Required PCB fixes for wiFred revisions 0.5 and 0.51

Intensive use of the wiFred of revisions 0.5 and 0.51 revealed a mistake in the way the LEDs and key switches are connected to the AVR on PCBs with rev0.5 and rev0.51: In certain situations, pressing one function key will be read as multiple key presses. This is most obvious with F2, F5 or F8 also activating ESTOP. This document describes a fix which has been implemented successfully in many wiFreds and also incorporated into the rev0.52 PCB and schematic. It removes the LEDs from the key read-in matrix.

Figure 1: PCB rev0.51 showing the half with resistors R302, R303 and R304 to be removed

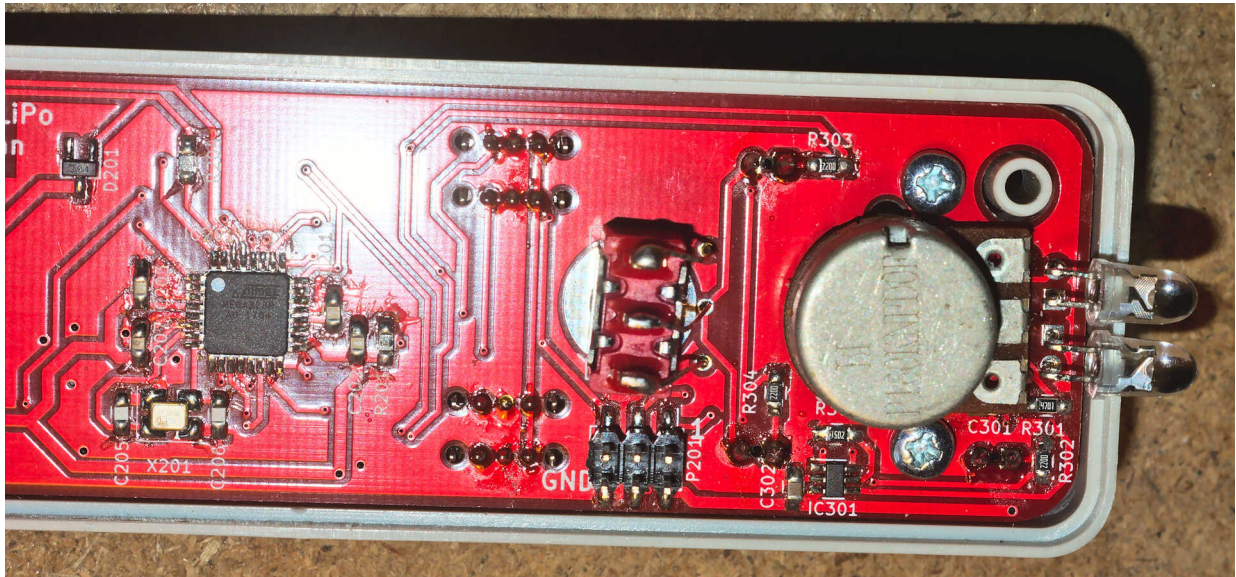
First, remove the SMD resistors R302, R303 and R304 as shown in Figure 1 and Figure 2 and clean their pads with some solder wick.

Figure 3: PCB rev0.51 with the first of three replacement resistors installed

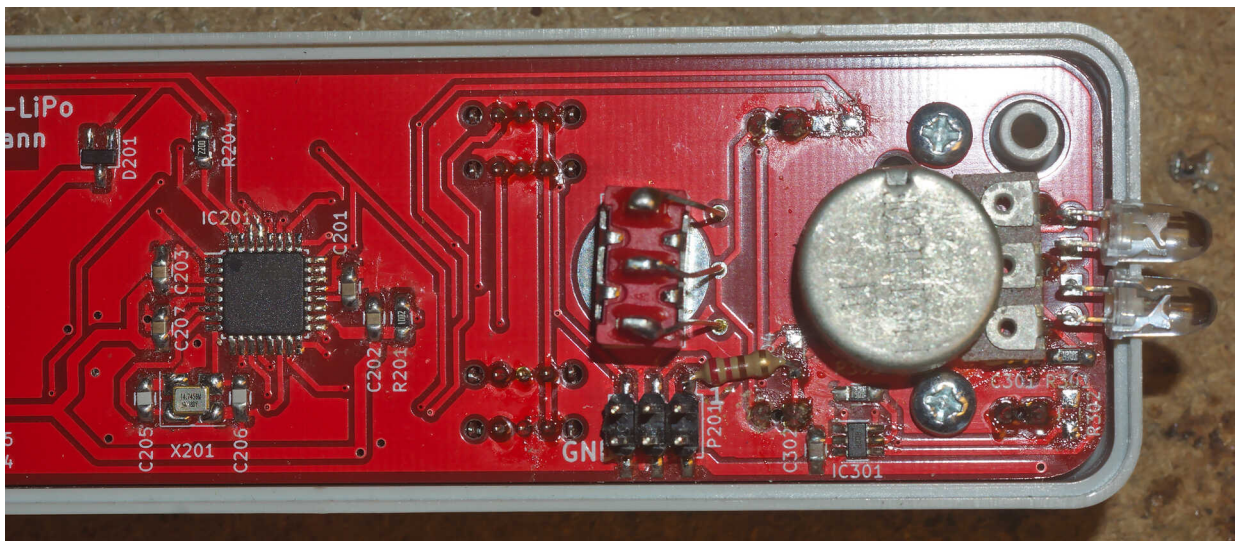
Next, get the first of the 220-Ohm THT resistors (size 0207), cut and bend the leads very short so it connects Pin 1 of P201 to the outer pad of former R304 and solder it as shown in Figure 3.

Figure 4: PCB rev0.51 with the second of three replacement resistors test-fit, but not yet soldered

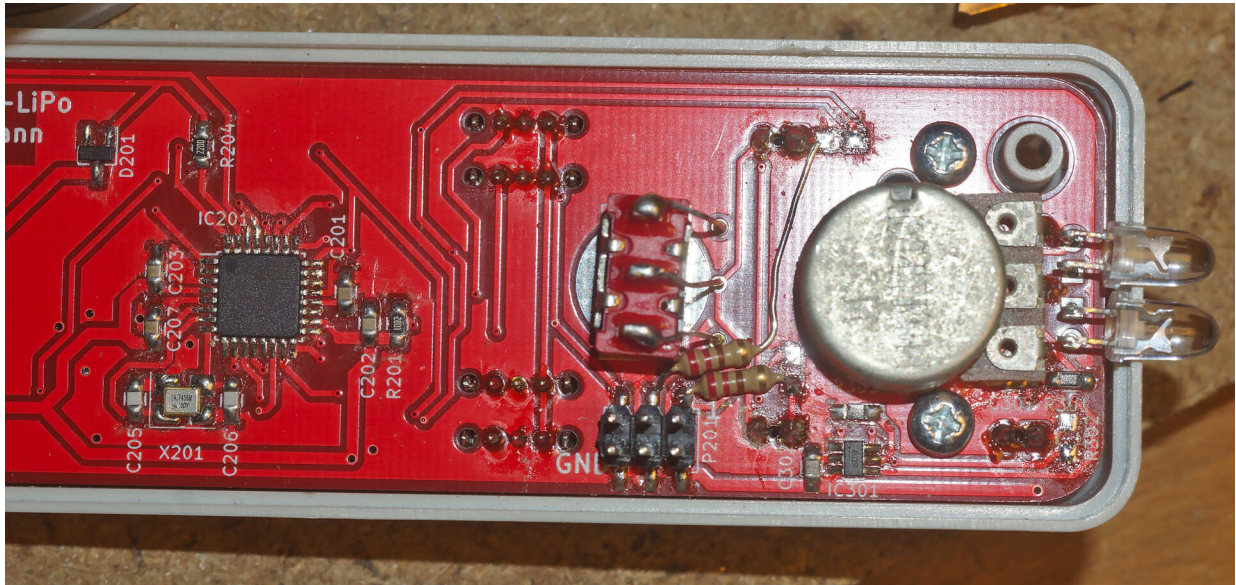
The second 220-Ohm THT resistors needs a little more shaping of its leads. It should connect pin 3 of P201 (center pin in the upper row) with the inner, left pad of former R303, as shown in Figure 4. As the longer lead of that resistor passes close to a couple of metal pieces in the wiFred, it is recommended to cut a piece of heat-shrink tube and fit it over the bare metal of the lead, as shown in Figure 5. It is not required to actually shrink it as it will be held in place by the resistor and the solder point.

Figure 6: PCB rev0.51 with all three replacement resistors installed

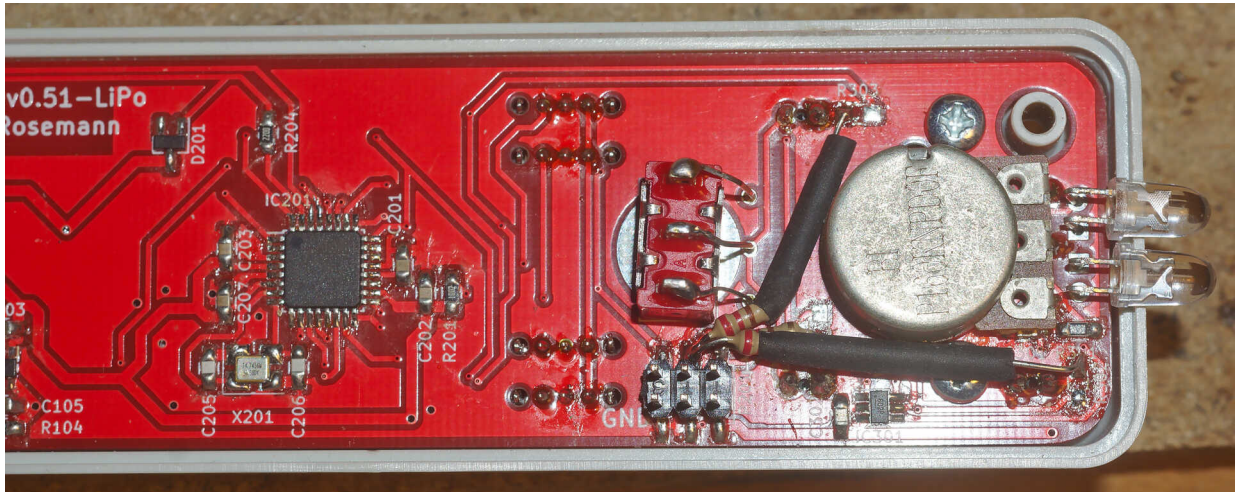
The final 220-Ohm THT resistor is installed in a similar fashion to the second one, also attaching to pin 3 of P201 and connecting it to the center (upper) pad of former R302 as shown in Figure 6. It also has a long bare lead floating close to other metal parts, so insulation with heat-shrink tube is recommended. Also it blocks access to the lower right (in the picture) screw attaching the PCB to the housing, so either bend it a little different from the picture, remove the screw or make sure access to the top side of the PCB is not required.
